Notice of Rescission of FAA Order 1050.1F, Availability of FAA Order 1050.1G, Request for Comments

Filed electronically through the [Federal Register, Docket ID: FAA-2025-1571](#)

Re: Request for an Extension of Public Comment Period for PIRAT STAR (RNAV)

Figure 4. Pacific 2 Tailored Arrival and the Proposed PIRAT STAR

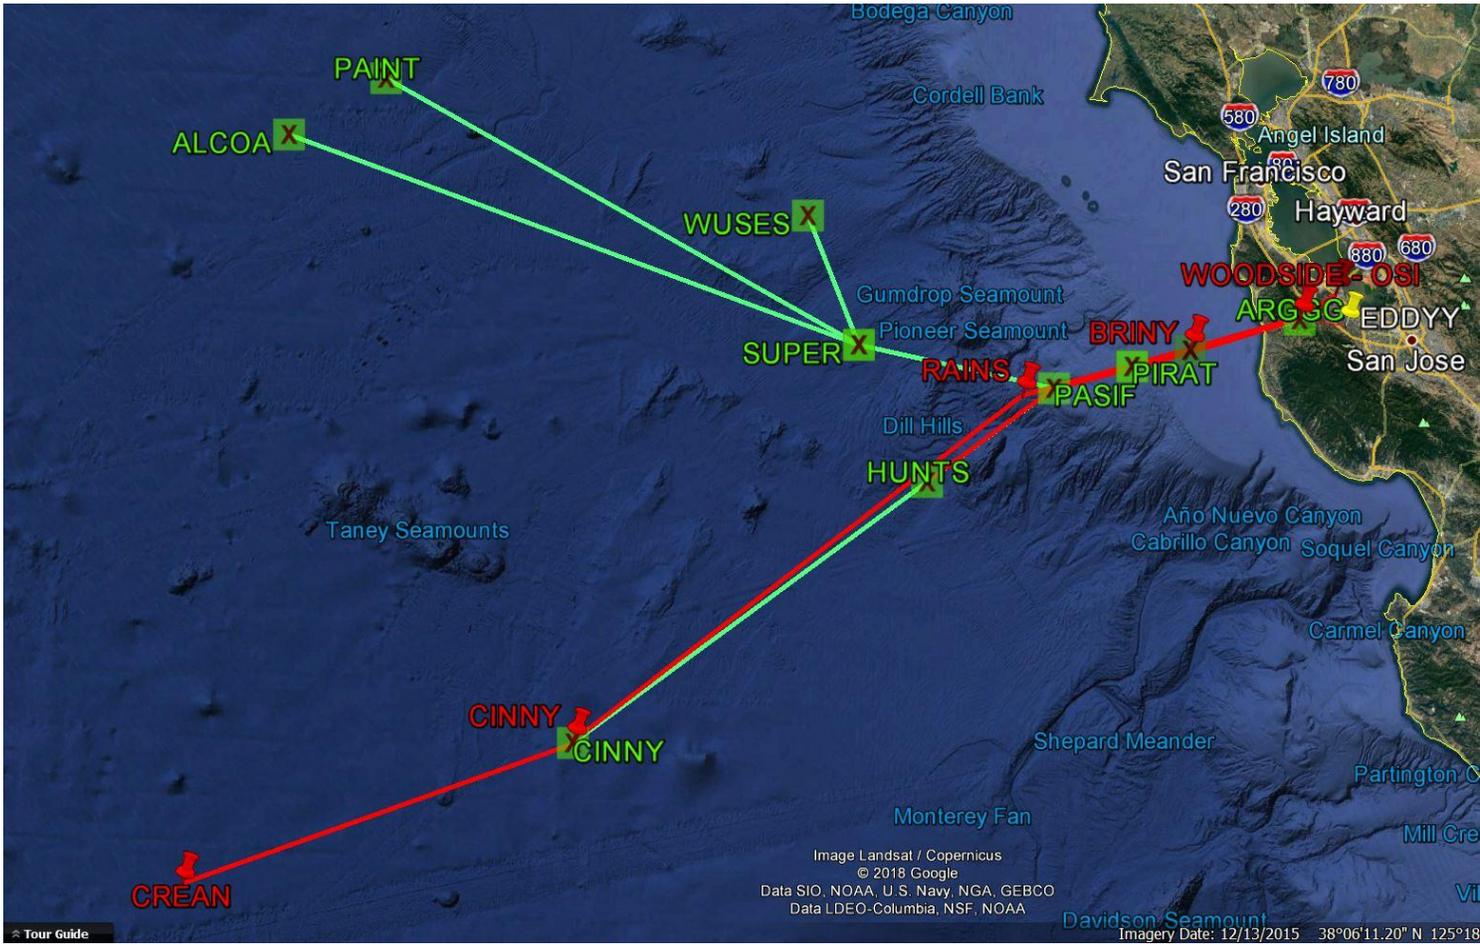
Members of our community and our technical consultants just recently (within the past week) brought this to my attention with great alarm. There is concern that the new procedure will increase the amount of flights currently using the OTA over Portola Valley, Woodside, Los Altos and Palo Alto. There is concern that this procedure has been developed without input from our communities with regard to altitudes and vectoring over the middle and southern San Francisco Peninsula. There are questions and concerns about whether the use of the previous San Francisco Class-B Airspace via the current San Francisco Class-B Airspace is still valid. There are many more areas of this procedure we need to analyze, and to do that, we believe a sixty (60) day extension is necessary. Therefore, we respectfully request a sixty (60) day extension of the public comment period.

We have several concerns about the potential impacts of the PIRAT route and ask the FAA to clarify the following issues related to routing paths and altitudes; air traffic volume; and noise and other environmental impacts, particularly given that one of NextGen's goals was to "take into consideration, to the greatest extent practicable, design of airport approach and departure flight paths to reduce exposure of noise and emissions pollution on affected residents."

I am concerned by the lack of community engagement by the FAA during the planning and execution of the proposed PIRAT Star changes to routes or procedures. Were standard FAA community engagement processes used for the proposed PIRAT Star changes to routes or procedures?

FAA Response: Assumption 1 is reasonable. The IER, upon which the FAA based its Categorical Exclusion (CATEX), assumes that the number of operations for oceanic arrivals to the Bay Area will not increase *as a result* of the new PIRAT STAR. The CATEX analysis was a comparison of the environmental impacts of the no action, or current state, compared to implementing the proposed action. A new procedure, such as the proposed action, provides a different navigational method but does not by itself

FAA Response: Assumption 2 is reasonable. Prior to the implementation of the PIRAT arrival procedure, oceanic arrivals to SFO and OAK were brought in one of two ways: 1) via the private Tailored Arrival, or 2) via Air Traffic Control (ATC) instruction to cross the PIRAT waypoint and, subsequently, Woodside Very High Frequency Omnidirectional Range (OSI) (most OAK arrivals were vectored north prior to reaching OSI). The Select Committee on South Bay Arrivals (SC) recommended aircraft at OSI be restricted to 8,000 feet Mean Sea Level (MSL) (SC Recommendation 2.3, R1). The SC also recommended revision of the private Tailored Arrival, so it, too, would be restricted to cross OSI at 8,000 feet MSL (SC Recommendation 2.3, R2). In response to these two SC recommendations, the FAA chose to combine the two arrival methods (the Tailored Arrival and ATC instruction) by creating the public PIRAT arrival procedure, which restricts all oceanic aircraft assigned to the procedure to cross the ARGGG waypoint at 8,000 feet MSL. The ground location of ARGGG waypoint and OSI differ by approximately 100 feet.
